Access Compliance Report

Public Rights-of-Way

(Curb Ramps)

Intersection ID: 10038345	Main Street: SOUTH_BV	Cross Street: N/A	Location: S
ADA ID: 73C2233863FE	Ramp Type: Perp	Initial Pass/Fail: Fail	Overall Compliance: No
Severity Score: 25			
Codes/Mitigation Info/Possible Solution		Field Measurements/Component Compliance

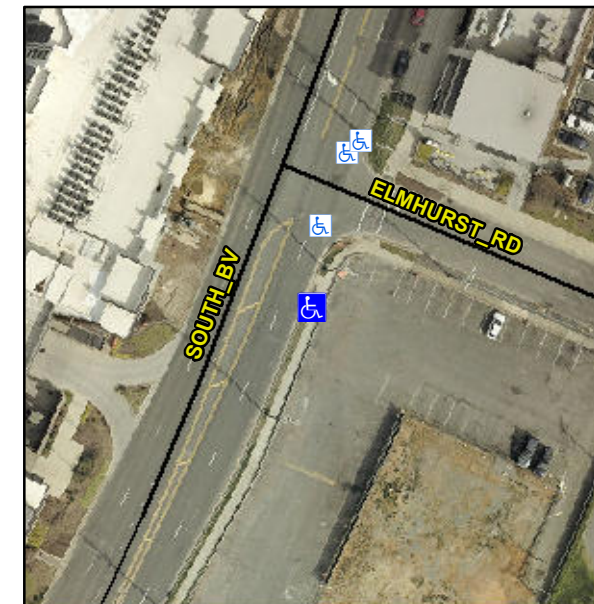
PROW/ADA:

R304.2.2

Compliance	Description	Data	Compliance	Description	Data
N/A	Ramp Length (in)	46.0	No	Ramp Slope (%)	12.4
Yes	Ramp Width (in)	48.0	Yes	Ramp XSlope (%)	0.7
N/A	Flare Type LT	N/A	N/A	Flare Type RT	N/A
N/A	Flare Slope LT (%)	N/A	N/A	Flare Slope RT (%)	N/A
N/A	Flare Traversable LT?	N/A	N/A	Flare Traversable RT?	N/A
N/A	Landing Length (in)	N/A	N/A	DWS Provided?	N/A
N/A	Landing Width (in)	N/A	N/A	DWS Contrast?	N/A
N/A	Landing Slope (%)	N/A	N/A	DWS Length (in)	N/A
N/A	Landing X Slope (%)	N/A	N/A	DWS Full Width?	N/A
N/A	Landing Curb? (Y/N)	N/A	N/A	DWS Offset (in)	N/A
N/A	Shared Landing?	N/A			
N/A	Gutter Ponding?	N/A	N/A	Gutter Slope (%)	N/A
N/A	Gutter Lip Ht (in)	N/A	N/A	Gutter X Slope (%)	N/A
N/A	Painted X Walk1?	No	N/A	Painted X Walk2?	N/A
	X Walk 1 Direction	To NW		X Walk 2 Direction	N/A
N/A	X Walk 1 Width (in)	N/A	N/A	X Walk 2 Width (in)	N/A
	X Walk 1 Slope (%)	2.8		X Walk 2 Slope (%)	N/A
	X Walk 1 X Slope (%)	0.1		X Walk 2 X Slope (%)	N/A

Remove & Replace Entire Ramp.
